SUBJECT: Transmittal of Westinghouse Responses to US NRC Requests for Additional Information on the AP1000 Application for Design Certification

# AP1000 DESIGN CERTIFICATION REVIEW

RAI Number: 220.010 (Response Revision 1)

Figure 3.8.3-4  
Reactor Vessel Supports

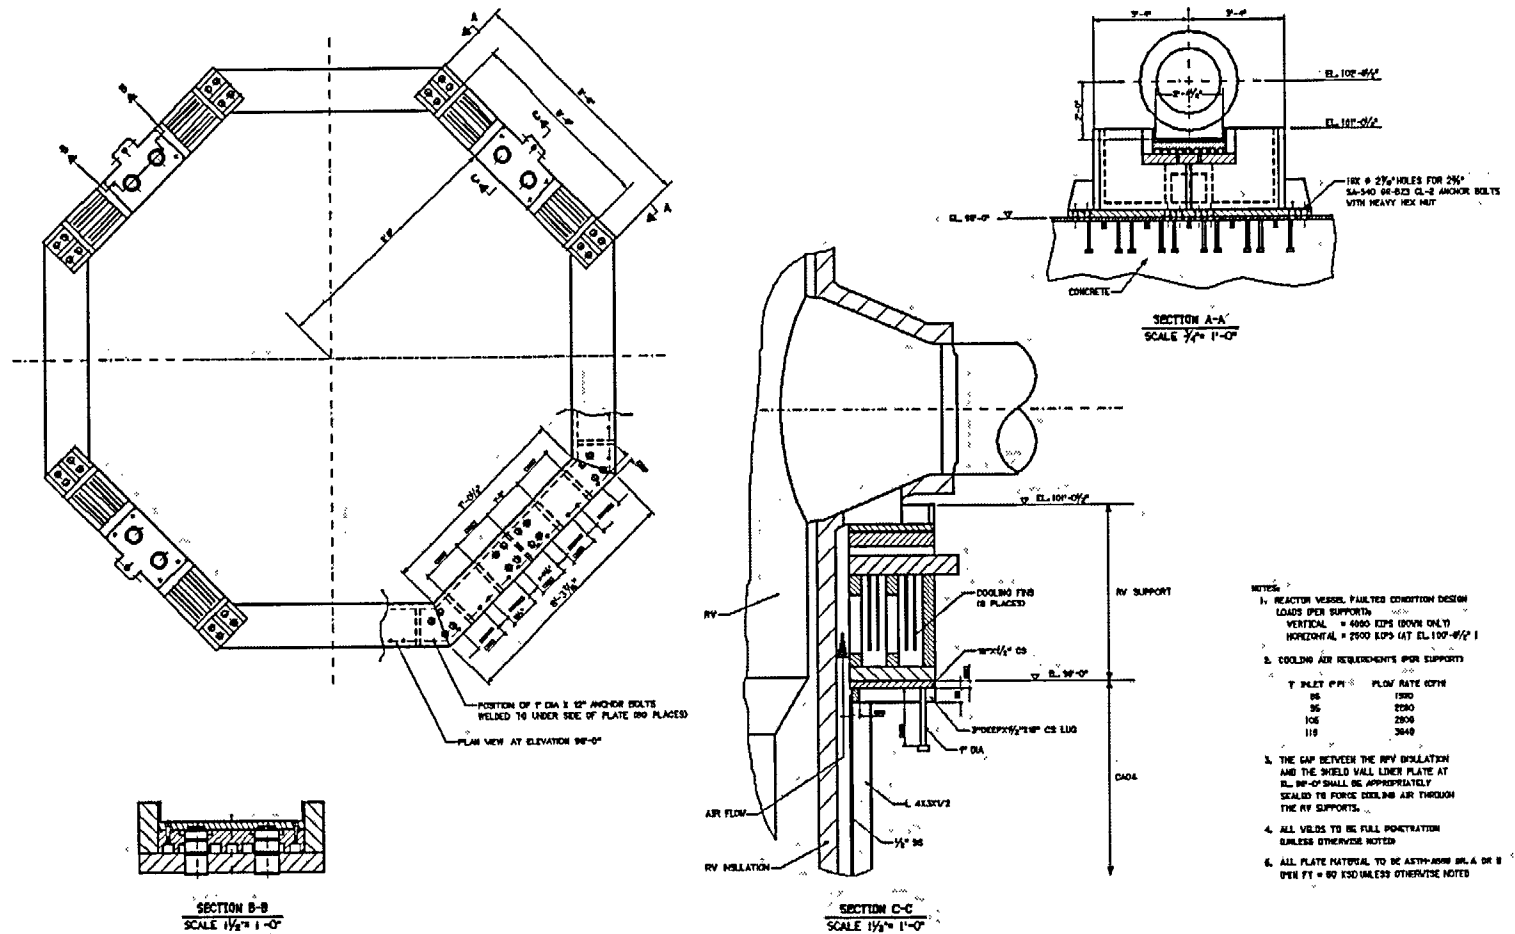
- A. Figure 3.8.3-4 does not provide sufficient details for the reactor vessel supports. More detailed information is needed, comparable to the level of details provided in the AP600 DCD, regarding the embedded anchor bolts, details about the embedded steel plates, provisions allowing for thermal expansion and seismic resistance, welds, and dimensions and sections of support elements.

The staff reviewed Westinghouse's response to this RAI provided at the meeting and found that the information is not complete to address the staff's concern. As a result of discussion, Westinghouse agreed to provide additional information about the anchorage of steam generator supports to module walls and also to provide larger, more easily readable copies of Figures 3.8.3-4 and 3.8.3-5 (sheets 1 and 2).

The embedded steel in the AP600 design has been incorporated into the CA-04 structural module for the AP1000. This module is shown in sheet 4 of DCD Figure 3.8.3-14. As depicted in DCD Figure 3.8.3-4 and in sheet 4 of DCD Figure 3.8.3-14, a horizontal octagonal plate is included as a flange at the top of the CA-04 structural module. The ASME-NF reactor vessel support is bolted to this horizontal plate. Vertical loads are carried through the plate and resisted by bearing on the concrete. Tangential loads (horizontal loads normal to the cold leg nozzle) are transferred into the concrete through shear lugs and headed anchors welded to the underside of the horizontal plate at the top of the CA-04 module. Radial loads are small due to the sliding bearing between the reactor vessel and the support.

DCD Figure 3.8.3-4 and sheet 4 of DCD Figure 3.8.3-14 will be revised as shown in attached figures.

Revise Figure 3.8.3-4 as shown in attached figure.

DCD subsection 3.8.3.1.1.2 is revised as shown below to provide additional information about the anchorage of the steam generator supports to module walls and adjacent structure. Figures 3.8.3-4 and 3.8.3-5 (sheets 1 and 2) have been included in Revision 3 of the DCD as 11" x 17" pages and are easily readable.

Figure 3.8.3-5 (Sheet 1 of 5) |  
Steam Generator Supports

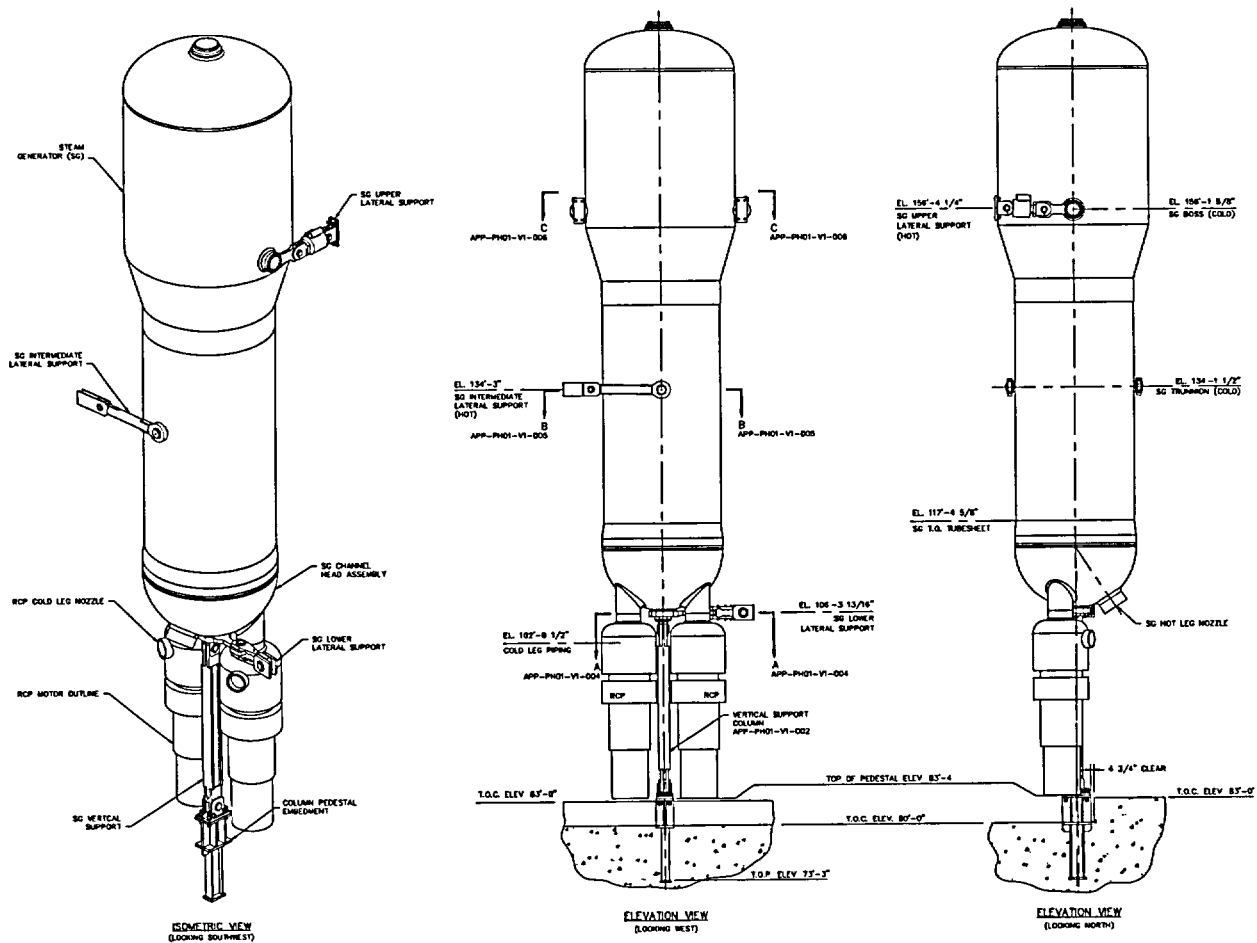
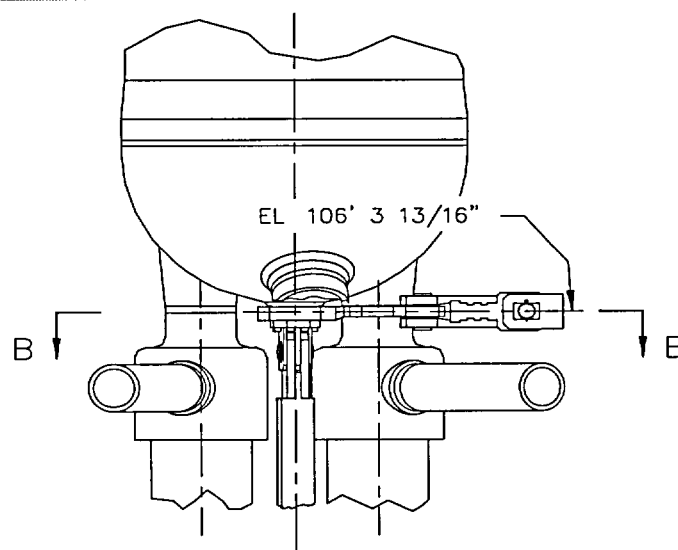
- B. Figure 3.8.3-5 does not provide sufficient details for the steam generator supports. More information needs to be provided, comparable to the level of details in the AP600 DCD.

- B. DCD Figure 3.8.3-5 will be revised as shown in attached figures to show details for the steam generator supports, comparable to the level of details in the AP600 DCD.
- D. The steel reinforcement in the containment internal structures concrete base was shown in DCD Figure 3.8.3-7 in the original issue of the AP600 DCD to provide typical details about steel reinforcement for all structures. Typical details were subsequently added for each critical section in Appendix 3H making the typical details shown in Figure 3.8.3-7 unnecessary. The figure was deleted in the AP1000 DCD because the internals structure base mat is not a critical section. The AP1000 reinforcement is similar to the AP600 reinforcement.

Add 4 sheets to Figure 3.8.3-5 as shown in attached figures.

**The steam generator supports are anchored using anchor bolts or steel weldments embedded in the concrete designed in accordance with Appendix B of ACI 349. The lower portion of the column pedestal is embedded in the concrete as shown on sheet 1 of Figure 3.8.3-5 and transfers the vertical load into the reinforced concrete basemat. The lower and intermediate horizontal supports are located so that the loads are transferred into the plane of the adjacent floor. The upper supports are located so that the loads are transferred into the plane of the steam generator compartment walls.**
